March 25, 2021
DAT-2021-010

Subject: The Boeing Company's Comments on Public Comment Draft Documents – Boeing Everett Facility

Ecology Draft Cleanup Action Plan

2-3 TCE Concentrations – PMG (Post-Interim Action Groundwater Conditions October ~~2019~~2020)

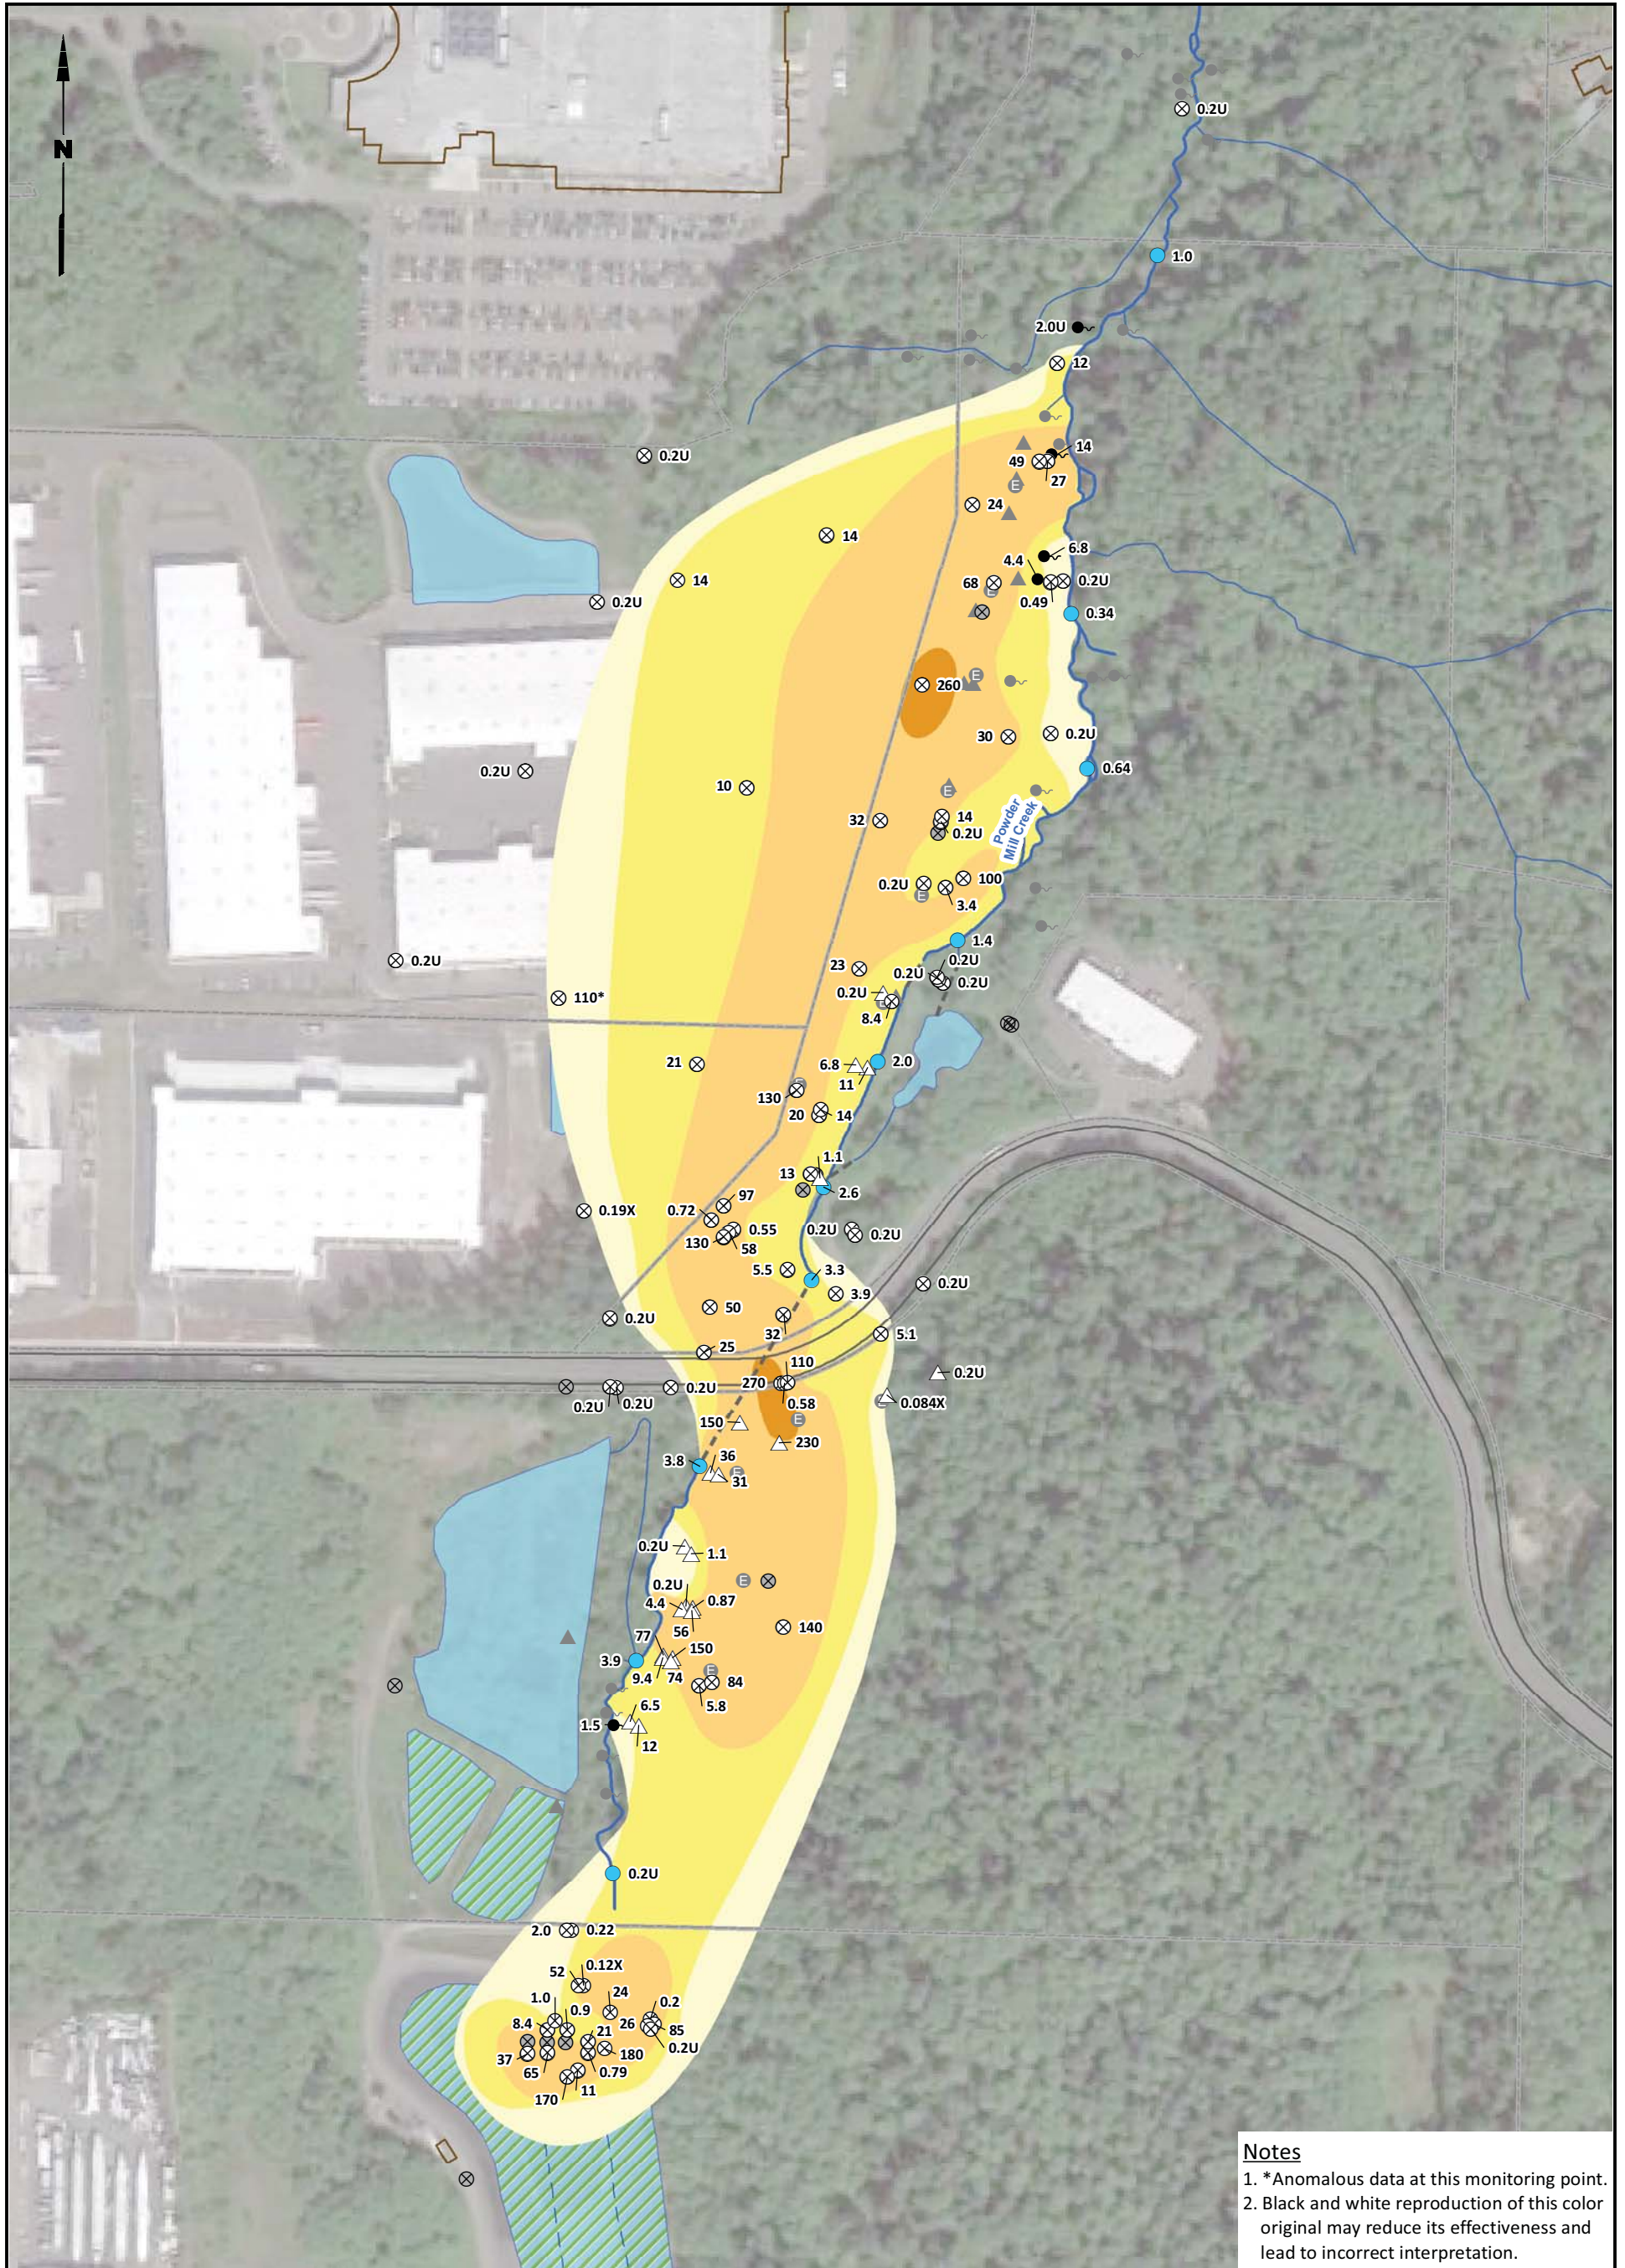
3. *Page 2-4, Last Paragraph (continuing onto Page 2-5) and Footnote 3.* This paragraph should be changed and the associated footnote deleted as follows to be factually accurate and provide more current and up-to-date information, and update figure number references (changes in red text and strikeout):

Note: Boeing has attached the most current TCE concentration contour map for October 2020 to replace DCAP Figure 2-3. Also, the list of figures for Section 2 (i.e., Figures 2-1 through 2-4) are out of order in the Table of Contents. Therefore, the DCAP table of contents should be change for these figures as follows to reflect these updates and proper order:

“As a result of implementation of the Source Area IA and Downgradient Plume IAs, TCE concentrations have decreased throughout much of the plume. However, groundwater chemical data indicates that the TCE groundwater plume is still (to a lesser extent) migrating across Seaway Blvd onto City of Everett (Lot #9), PMBC and Seaway Center properties. Figures 2-~~42~~ and 2-~~23~~ show, respectively, TCE iso-concentration contours from 2012 prior to the implementation of any IAs, and recent data from October 20~~20~~19. As indicated by the data represented in Figure 2-~~23~~, as a result of the source area IA, source area TCE concentrations

have been reduced from over 2,500 µg/L at multiple wells (with a measured maximum concentration of 31,000 µg/L in 2005) to a maximum concentration of ~~330-180~~ µg/L as of ~~April October~~ 2020. TCE concentrations in the downgradient plume have also substantially declined as a result of the source area and Downgradient Plume IAs, from a high concentration of 1,900 µg/L to a maximum concentration of ~~480-270~~ µg/L as of ~~February-October~~ 2020. ~~However, TCE concentrations have increased on the western boundary³ of the downgradient plume on the PMBC and Seaway Center properties (up to 300 µg/L recently). These elevated concentrations have been routinely observed in groundwater monitoring wells EGW171R2 and EGW174 for several years and these groundwater chemical data are accurate and represent TCE concentrations on the western boundary of the downgradient plume and not anomalous.”~~
